Access Compliance Report

Public Rights-of-Way

Intersection ID: 10011781	Main Street: PIERSON_DR	Cross Street: N/A	Location: S
ADA ID: C76E279CE9C1	Ramp Type: Perp	Initial Pass/Fail: Fail	Overall Compliance: No
		Severity Score: 25

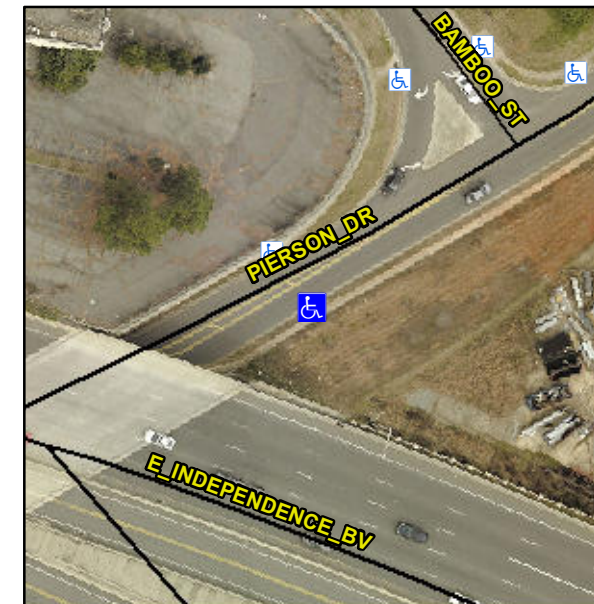
Not Found, R304.5.3

Compliance	Description	Data	Compliance	Description	Data
N/A	Ramp Length (in)	85.0	Yes	Ramp Slope (%)	8.1
Yes	Ramp Width (in)	70.0	No	Ramp XSlope (%)	7.1
N/A	Flare Type LT	N/A	N/A	Flare Type RT	N/A
N/A	Flare Slope LT (%)	N/A	N/A	Flare Slope RT (%)	N/A
N/A	Flare Traversable LT?	N/A	N/A	Flare Traversable RT?	N/A
N/A	Landing Length (in)	N/A	N/A	DWS Provided?	N/A
N/A	Landing Width (in)	N/A	N/A	DWS Contrast?	N/A
N/A	Landing Slope (%)	N/A	N/A	DWS Length (in)	N/A
N/A	Landing X Slope (%)	N/A	N/A	DWS Full Width?	N/A
N/A	Landing Curb? (Y/N)	N/A	N/A	DWS Offset (in)	N/A
N/A	Shared Landing?	N/A			
N/A	Gutter Ponding?	N/A	N/A	Gutter Slope (%)	N/A
N/A	Gutter Lip Ht (in)	N/A	N/A	Gutter X Slope (%)	N/A
N/A	Painted X Walk1?	No	N/A	Painted X Walk2?	N/A
	X Walk 1 Direction	To N		X Walk 2 Direction	N/A
N/A	X Walk 1 Width (in)	N/A	N/A	X Walk 2 Width (in)	N/A
	X Walk 1 Slope (%)	2.8		X Walk 2 Slope (%)	N/A
	X Walk 1 X Slope (%)	6.3		X Walk 2 X Slope (%)	N/A

Remove & Replace Entire Ramp.
